Title: STAGE 1 ROAD SAFETY AUDIT

**Proposed Residential Development at Seamount, Malahide,
Co. Dublin**

Client: Waterman Moylan

Report reference: 0666R01

Drawing P313 Rev -, Proposed Entrance sightlines.

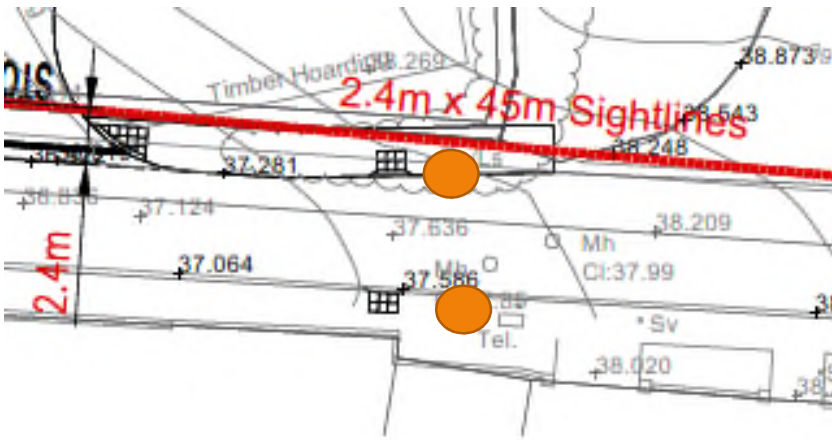
It is proposed to provide an informal pedestrian crossing on Seamount Road to the East of the new junction. The proposed location of the dropped kerb and tactile paving is adjacent to ESB/PL/Telecom poles. The presence of the poles could obscure visibility between pedestrians and drivers resulting in collisions with crossing pedestrians.

It is recommended that the crossing location be changed to a location where the poles are regarded as momentary obstructions or alternatively the poles should be relocated outside the required visibility envelope for crossing pedestrians.

Paragraph No. in Safety Audit Report	Problem accepted (yes/no)	Recommended measure accepted (yes/no)	Alternative measures (describe) / Comment	Alternative measures accepted by Auditors (Yes/No)
3.1	Y	Y	Additional calming added	Yes
3.2	Y	Y	Pedestrian crossing can be relocated as required	Yes
3.3	Y	Y	Dwell area added – 7m	Yes
3.4	Y	Y	Min. 5.5 m driveways confirmed	Yes

Drawing P302 & P302 Rev A. Proposed Roads and Levels layout.

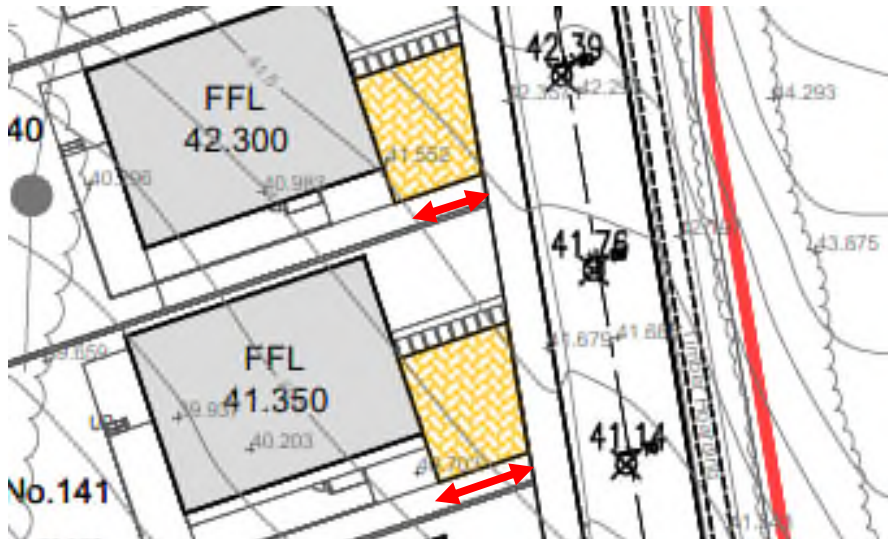
It is unclear if a dwell area has been provided on approach to the new junction from within the development. If there are excessive gradients at the stop line this could result in overshoot onto Seamount Road which could result in side-impact collisions, especially in frosty conditions.

It is recommended that a suitable dwell area be provided.

Drawing P302 & P302 Rev A. Proposed Roads and Levels layout.

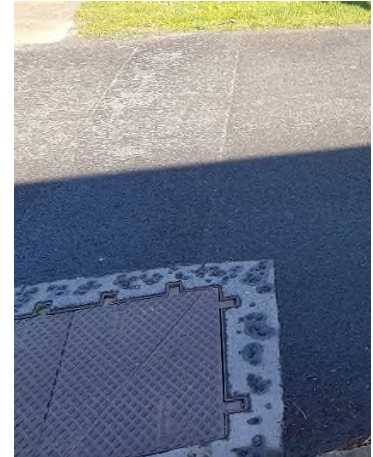
Some of the parking spaces in front of the residential units on the main access road appear to be shorter than the 5m shown in the typical cross section. This could lead to vehicles overhanging the footpath resulting in pedestrians entering the carriageway where they would be at greater danger of being struck by passing vehicles.

It is recommended that a minimum of 5m parking width be provided plus a buffer zone to the residential unit.

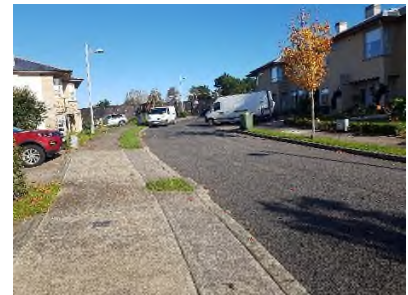
The cross section of the existing road in Seamount Abbey has a verge and a footway to the rear. The proposed extension has just a footway on both sides. The tie-in detail will have to be developed at the detailed design stage.
